RE: Stormwater Analysis – 51 S. Main Apartments
51 South Main Street, Waterbury, Vermont

51 S. Main St. – DRB comment response

Original DRB comment list.

L2.0

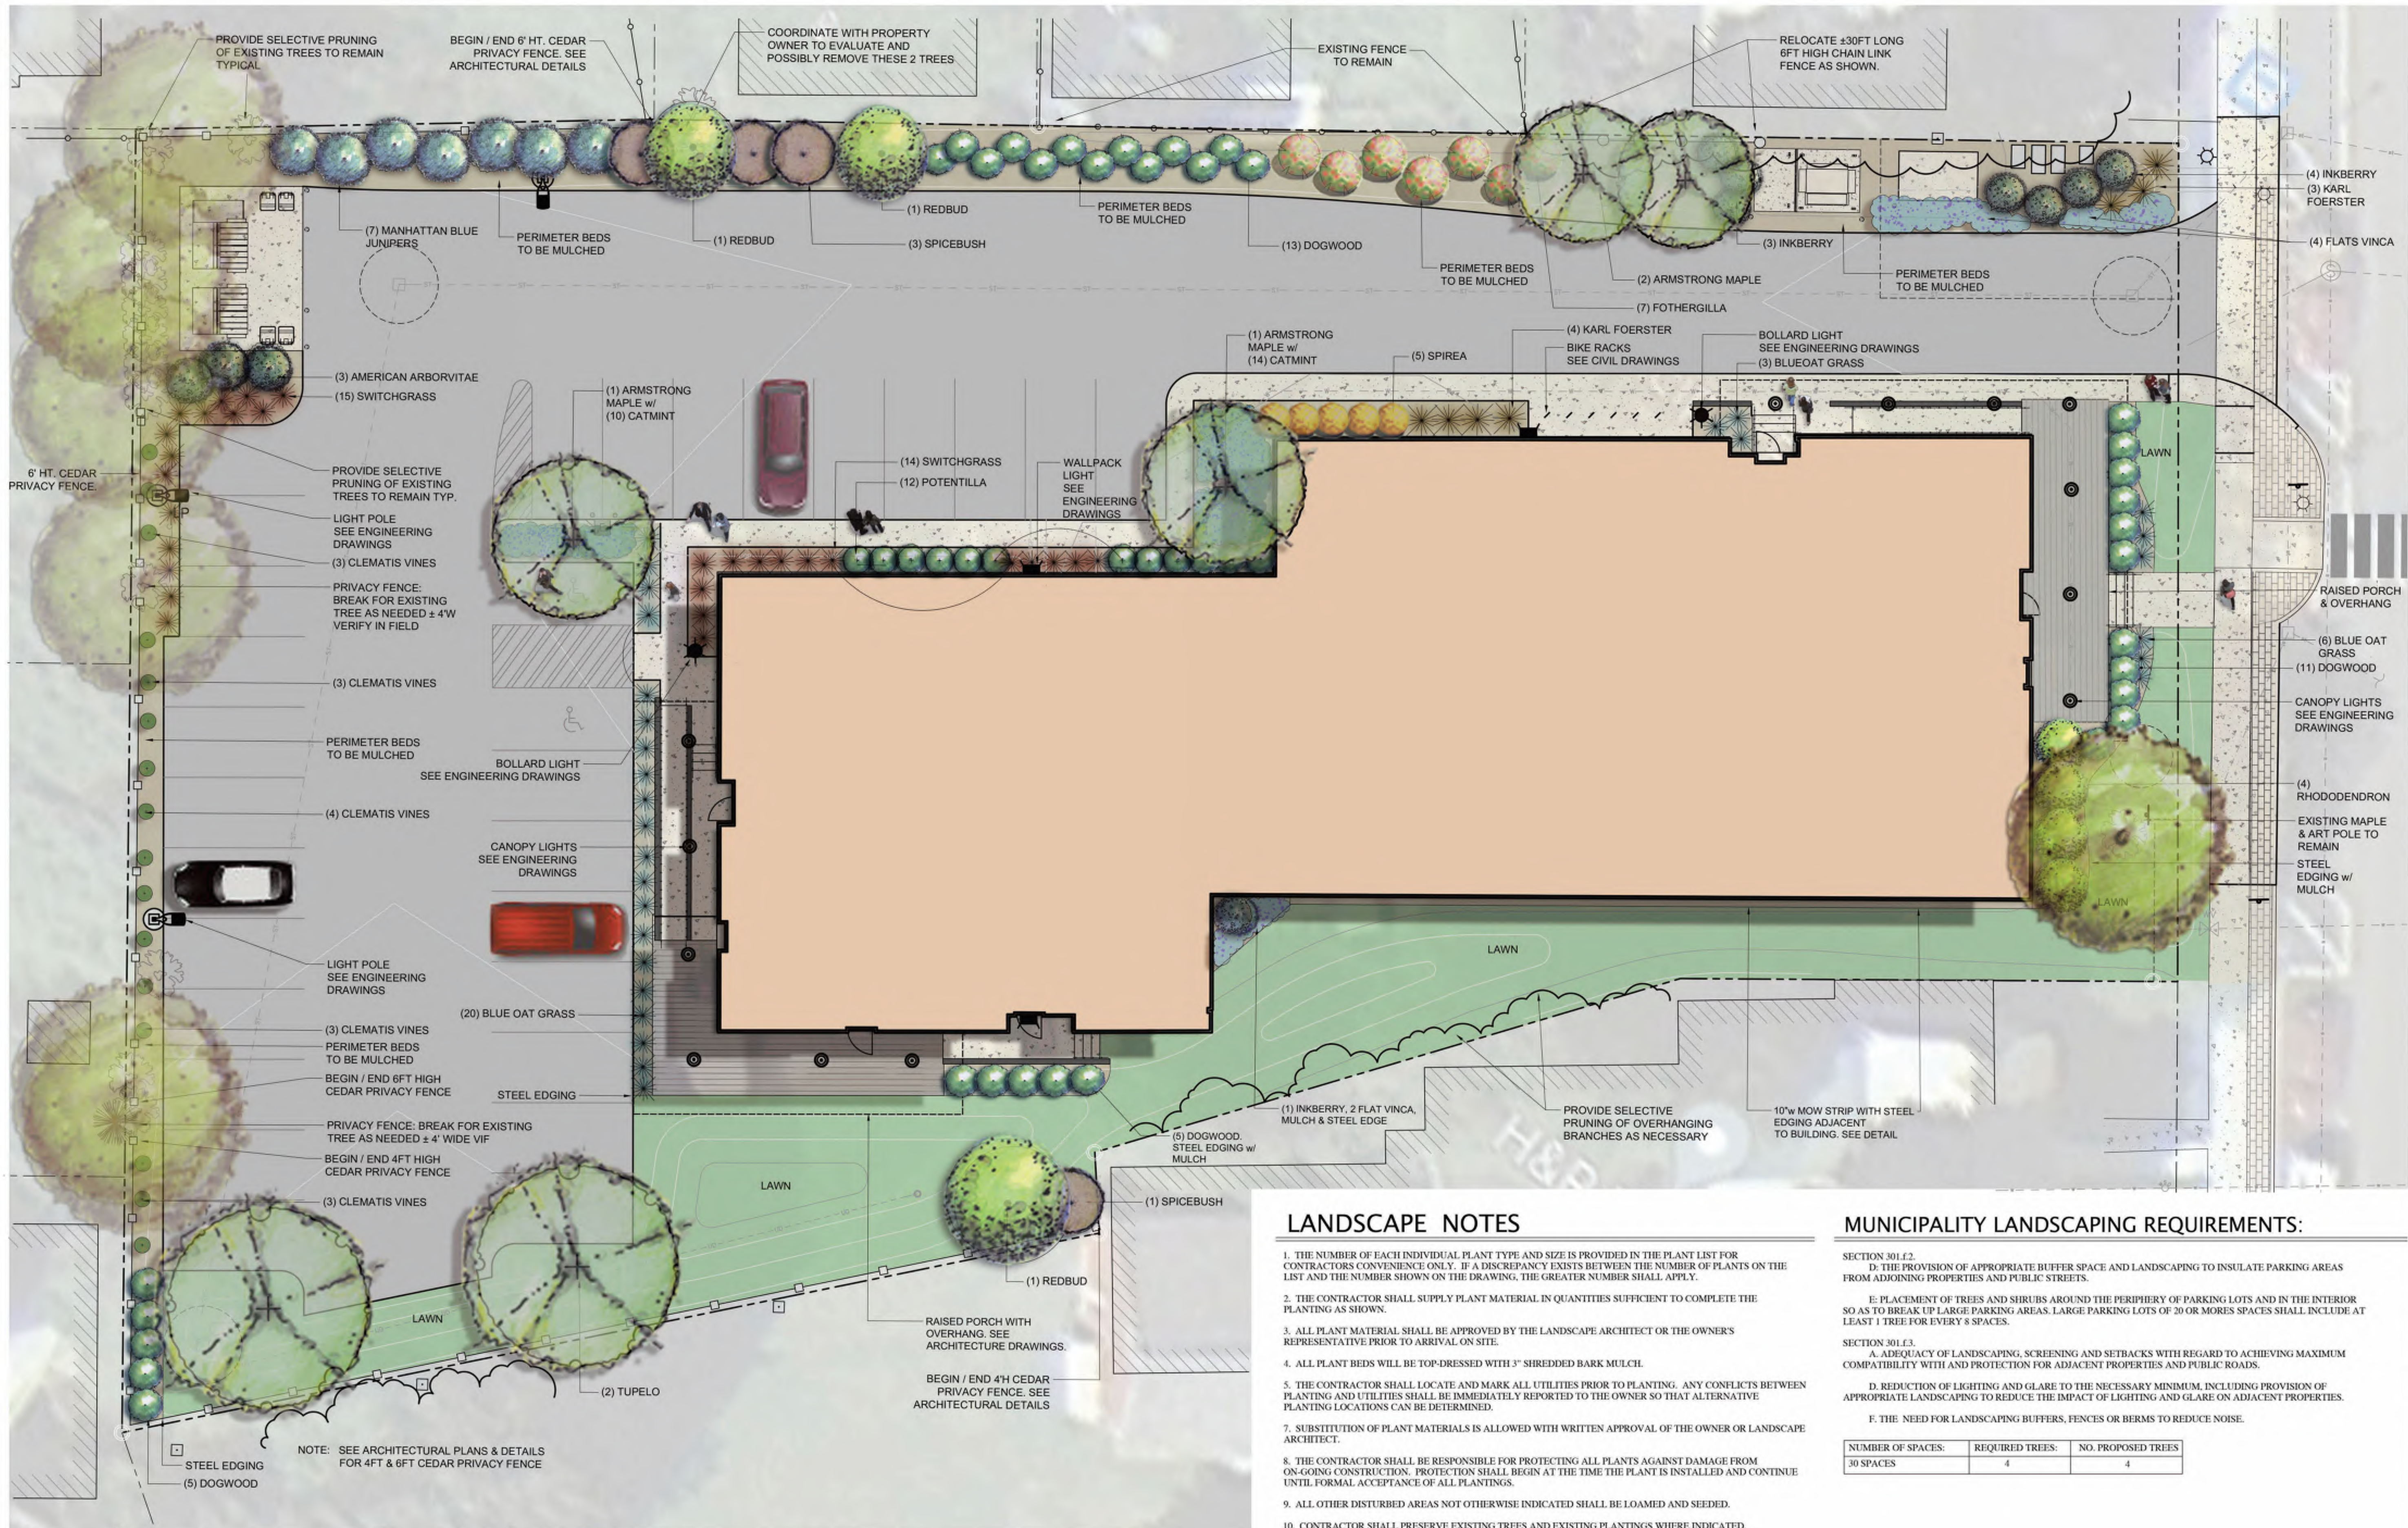
A Redbud tree has been added along the southern property line for screening. We also fully intend to keep as much of the existing “cedar” screening as possible along the existing historic building, doing only selective trimming on our property where necessary. After meeting with neighbors on an individual basis we are doing our best to save or reintroduce trees in additional areas. We will be modifying 3 spaces on the western property line to make them compact car parking so we can save an existing tree at this location. We will also look at saving some of the existing trees near the service station. As well as adding two new trees for further screening and shading.
See L2.0 & L2.1

ELEVATIONS
- COLOR

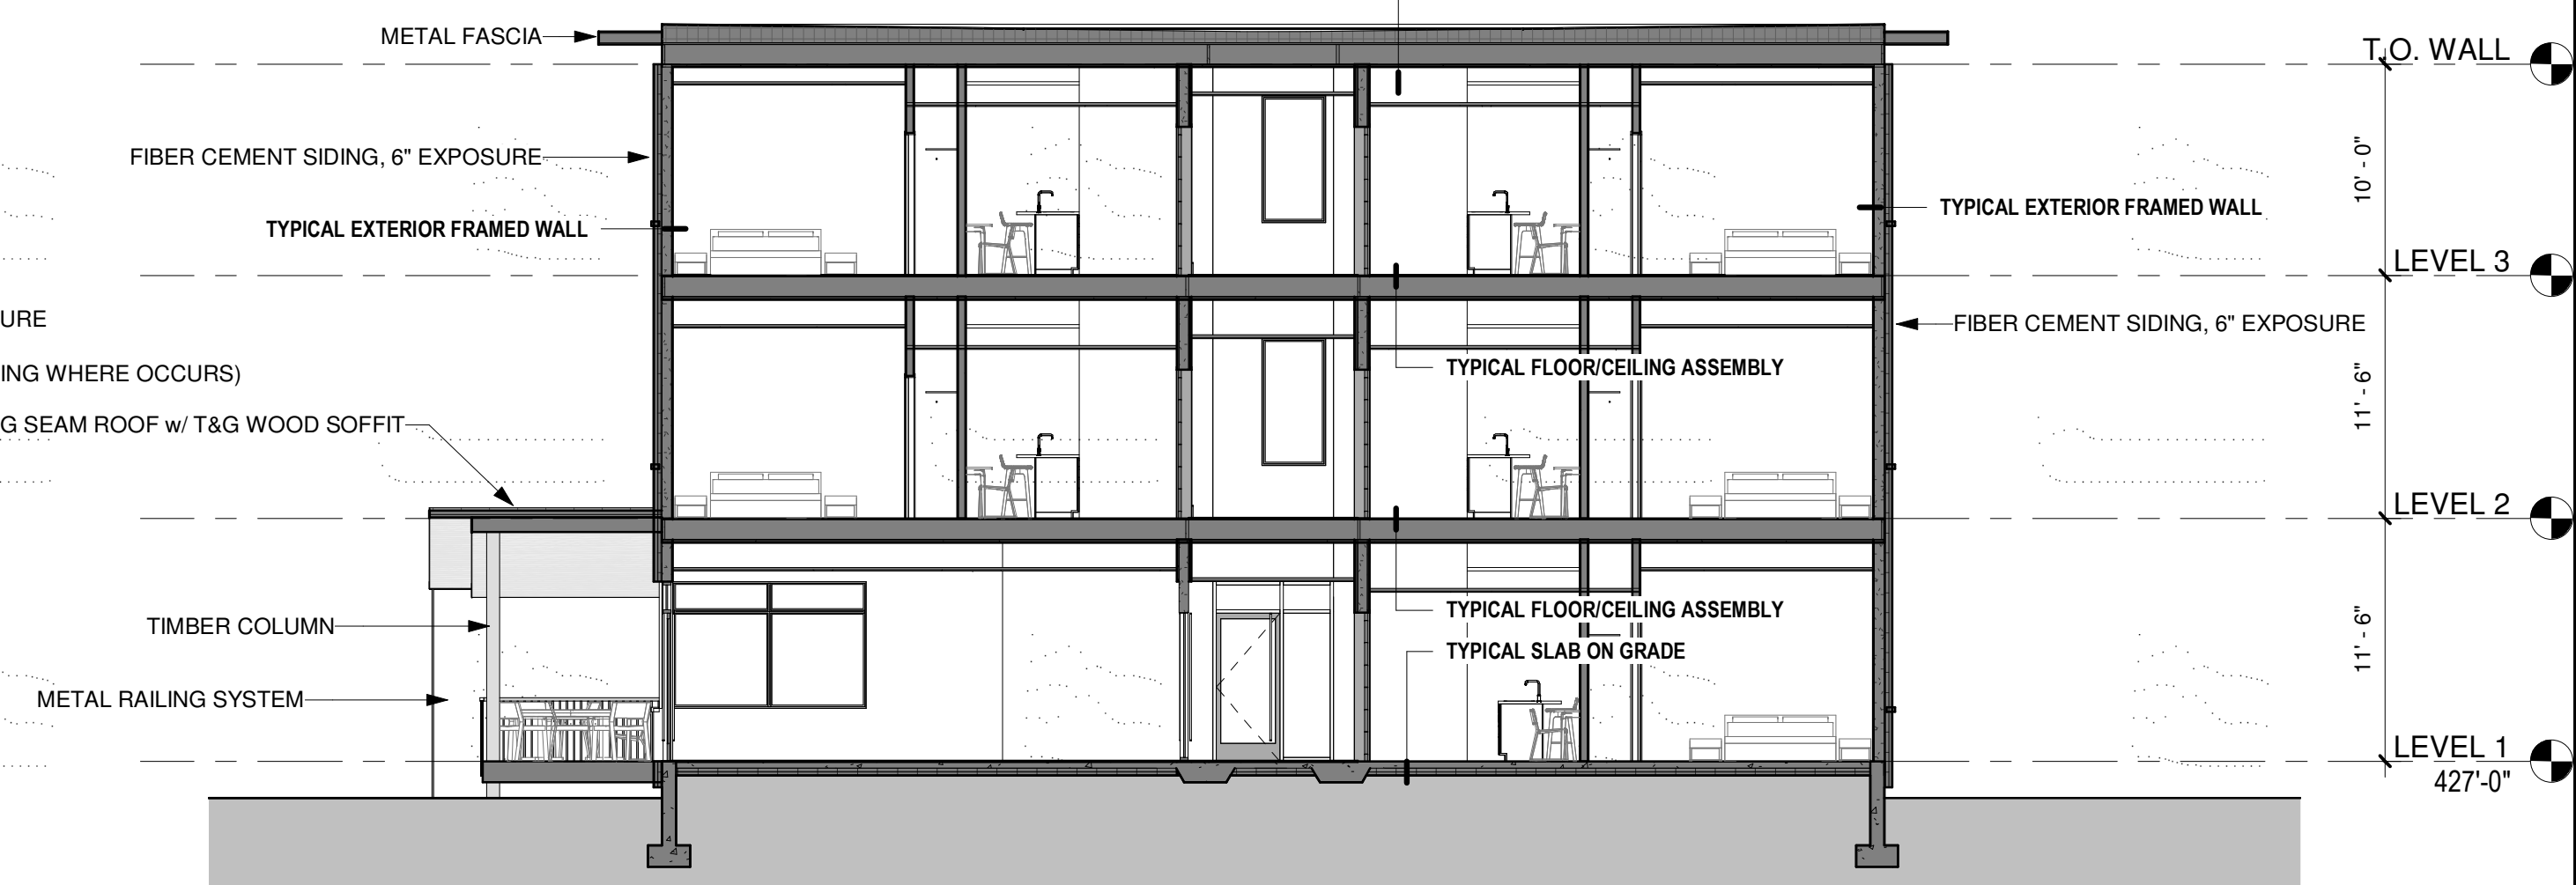
- **Change the 90-degree angle window on the NE corner on the 2nd floor**
We have greatly diminished the size of the NE corner on the 2nd floor to make it feel more residential and reduce the amount of glazing on a prominent corner of the building. This reduction allowed us to include a second window on the north side of the building. This new window fits with the regular pattern of windows along that facade, enhancing the historic feel. We will also include a brick detail at the sill and head of the window to further reference historic brick patterns. All residential windows will be fitted with blinds provided by Downstreet.
Window update can be seen on A200 & A400

The area referenced in this comment has been brought down by +/-2'-0". We agree that this change has positive affect on reducing the scale of the building. We have also provided a more defined cornice in that area to again reference, but not mimic, a historic building feature seen on other brick buildings in the historic downtown.
Height update can be seen on A200 & A400
Cornice detail added to A200
- **Provide color options for the siding**
